COLECO ADAM C88

7-PIN DIN AUDIO BALANCE FIX

TECHNICAL
SERVICE BULLETIN

JL-DELTA-01
REVISION A
4/21/2021

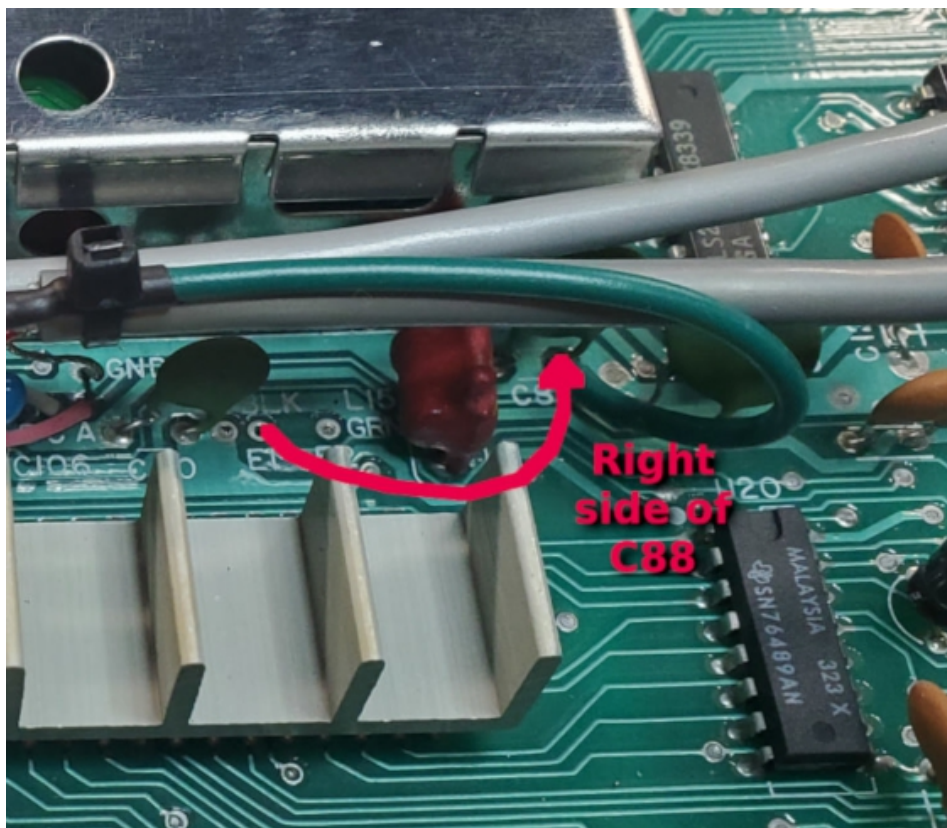
SUBJECT: USERS WILL EXPERIENCE UNBALANCED AUDIO AT THE 7-PIN DIN WHILE USING EXTERNAL I/O EXPANSION DEVICES THAT GENERATE SOUND

A design flaw has the audio connection source to the 7-Pin DIN incorrectly placed. The standard E1 connection by Coleco is connected to the wrong side of R18 (1.8K). This incorrect position has the ADAM and I/O expansion audio sources on opposite ends of the resistor and therefore causing the unbalanced audio. This flaw is especially noticeable while using the Super Game Module (SGM).

To correct this issue, the audio source E1 needs to be moved. Since R18 is under the RF Module, the same connection can also be made by moving the E1 wire to the right side of the easier to reach C88.

Optionally, for even better sound, Coleco also failed to add the appropriate .1uF capacitor for blocking DC level component in the audio line as well. They do have this correct to the RF board through C100, but the audio to the 7-Pin DIN does not have a capacitor to compensate for this. It is recommended to add an additional .1uF capacitor in-line with the audio wire from the new C88 position to the 7-Pin DIN.
